Access Compliance Report

Public Rights-of-Way

(Curb Ramps)

Intersection ID: 27190	Main Street: BALLANTYNE COMMONS PY	Cross Street: WOODVIEW CR	Location: SE
ADA ID: 23D6CDE24C42	Ramp Type: PerpDiag	Initial Pass/Fail: Fail	Overall Compliance: No
Severity Score: 37.5			
Codes/Mitigation Info/Possible Solution		Field Measurements/Component Compliance

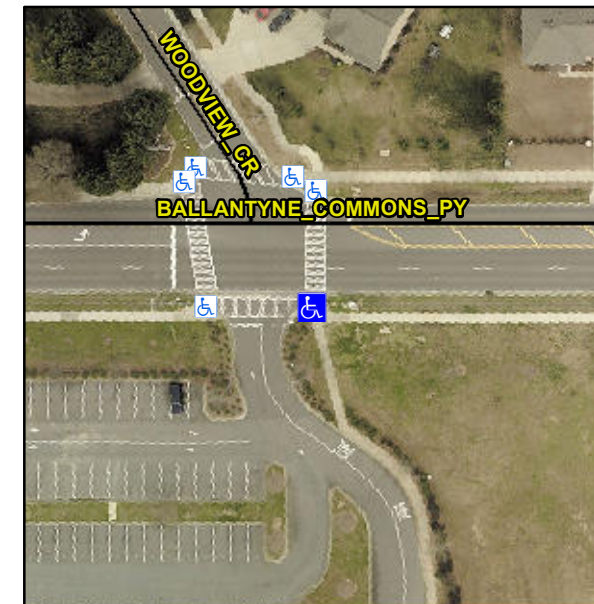
Not Found, R304.2.2, R304.5.3

Compliance	Description	Data	Compliance	Description	Data
N/A	Ramp Length (in)	83.0	No	Ramp Slope (%)	13.1
Yes	Ramp Width (in)	152.0	No	Ramp XSlope (%)	6.4
N/A	Flare Type LT	N/A	N/A	Flare Type RT	N/A
N/A	Flare Slope LT (%)	N/A	N/A	Flare Slope RT (%)	N/A
N/A	Flare Traversable LT?	N/A	N/A	Flare Traversable RT?	N/A
N/A	Landing Length (in)	N/A	N/A	DWS Provided?	N/A
N/A	Landing Width (in)	N/A	N/A	DWS Contrast?	N/A
N/A	Landing Slope (%)	N/A	N/A	DWS Length (in)	N/A
N/A	Landing X Slope (%)	N/A	N/A	DWS Full Width?	N/A
N/A	Landing Curb? (Y/N)	N/A	N/A	DWS Offset (in)	N/A
N/A	Shared Landing?	N/A			
N/A	Gutter Ponding?	N/A	N/A	Gutter Slope (%)	N/A
N/A	Gutter Lip Ht (in)	N/A	N/A	Gutter X Slope (%)	N/A
N/A	Painted X Walk1?	Yes	N/A	Painted X Walk2?	Yes
	X Walk 1 Direction	To N		X Walk 2 Direction	To W
N/A	X Walk 1 Width (in)	112.0	N/A	X Walk 2 Width (in)	102.0
	X Walk 1 Slope (%)	4.9		X Walk 2 Slope (%)	2.3
	X Walk 1 X Slope (%)	0.9		X Walk 2 X Slope (%)	6.5

N/A	Ramp inside XWalk1?	Yes	N/A	Ramp inside XWalk2?	Yes
	Road Slope (%)	6.1	N/A	Clear Space?	N/A
	Road X Slope (%)	5.2	N/A	Clear Space to XWalk (in)	N/A
N/A	Any Obstructions?	N/A	N/A	Storm Grate/Utility Hazard?	N/A
	Obstruction Type			Storm Grate/Utility Type	
		N/A			N/A
		Yes		Surface Condition? (G/P)	Good

Remove & Replace Curb Ramp With Two New Directional Ramps or Equivalent.
